Meek Sweater & Fashions Ltd.

Plot No: 1693, Bashon Sarak; Gazipur
(23.973789N, 90.374398E)
13th May 2018

Observations

Observation: Production building

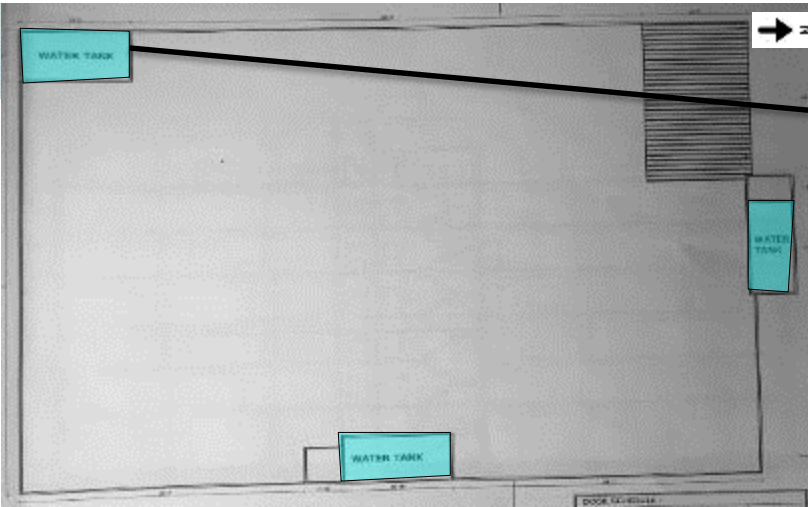
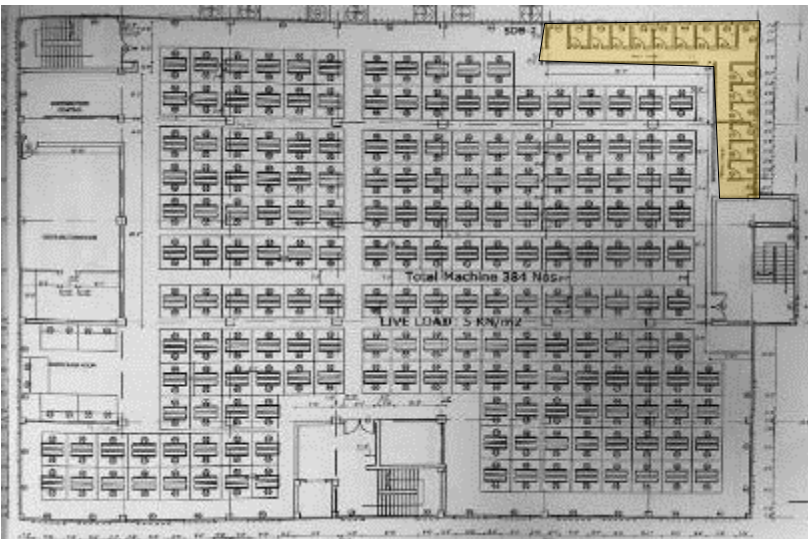
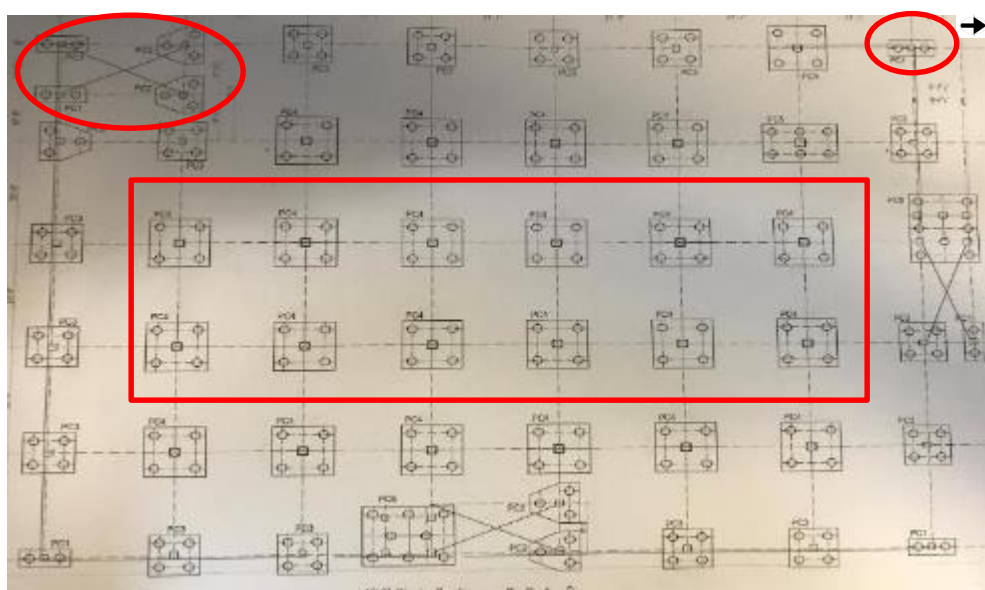
Cursory calculation indicates that highlighted columns appear to be stressed above normal design limits due to over head water tank and brick wall & floor built-up of toilet area. Factory engineer needs to check column stress as a part of Detail Engineering Assessment(DEA) . Factory should take necessary action according to report.

Water tank (6.8mx3.1mx1.4m)

200mm built-up and 125mm thick outer brick wall on toilet area

Foundation layout plan

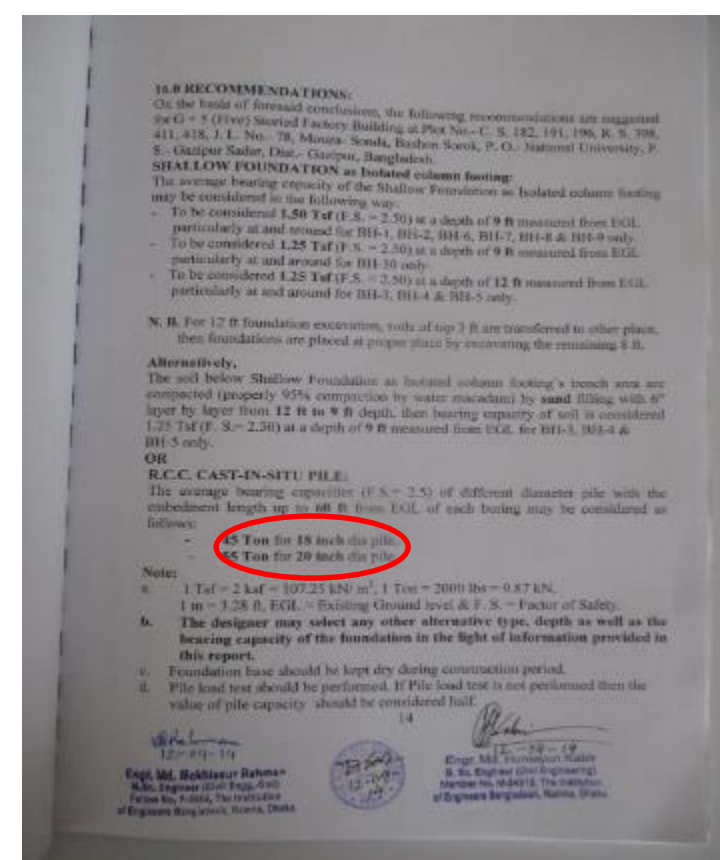
Cursory calculation considering the pile capacity based on soil test report indicates that pile appears to be stressed above normal design limits at marked zone. Factor of safety (FoS) is less than the minimum requirement of BNBC. Factory engineer is required to review the adequacy of pile considering actual bearing capacity of soil and comply with BNBC.

Water ingress on beam to wall joint

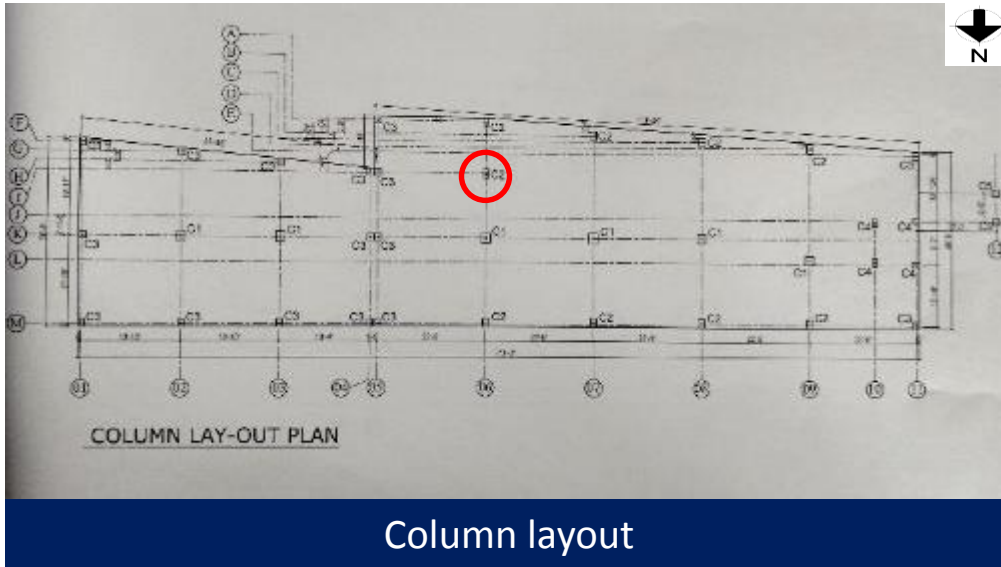
Water ingress was found on 5th floor at joint of beam and wall on south side.

Water ingress was found in several locations along with the beam to wall joint on south side. Factory engineer is required to take proper remediation for preventing further water ingress.

Column layout

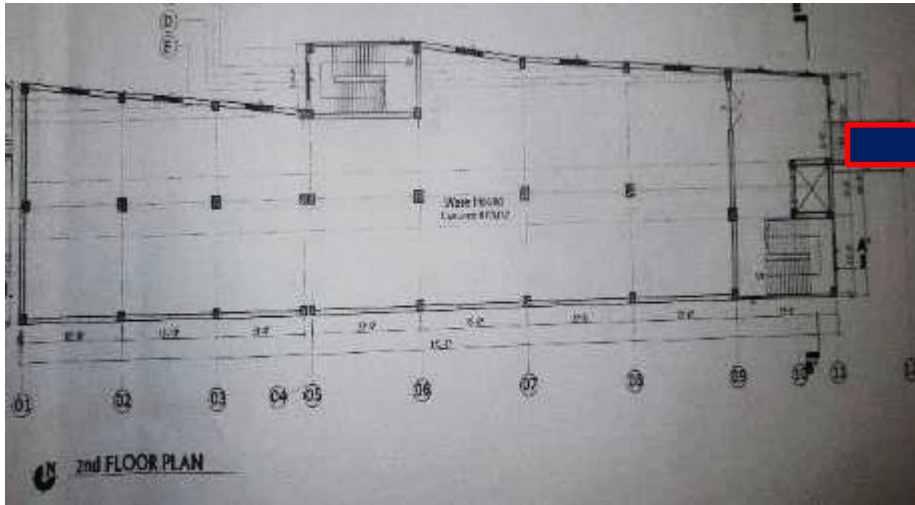
Cursory calculation indicates that highlighted columns appear to be stressed above normal design limits due to loads of water tanks and brick walls of toilet areas. Factory engineer need to check column stress as a part of Detail Engineering Assessment (DEA) and factory should be take necessary action according to report.

Grade beam Layout

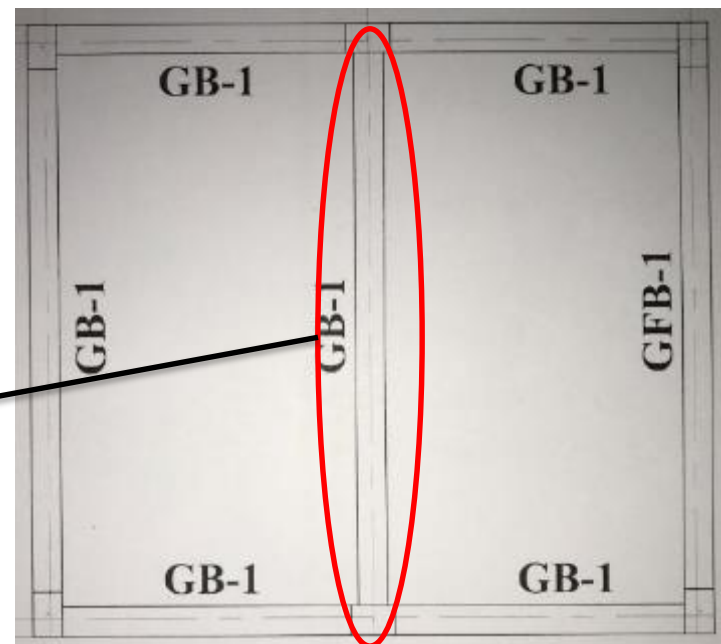
The marked grade beam was not found on site

Factory is required to revise as-built drawings as per actual condition
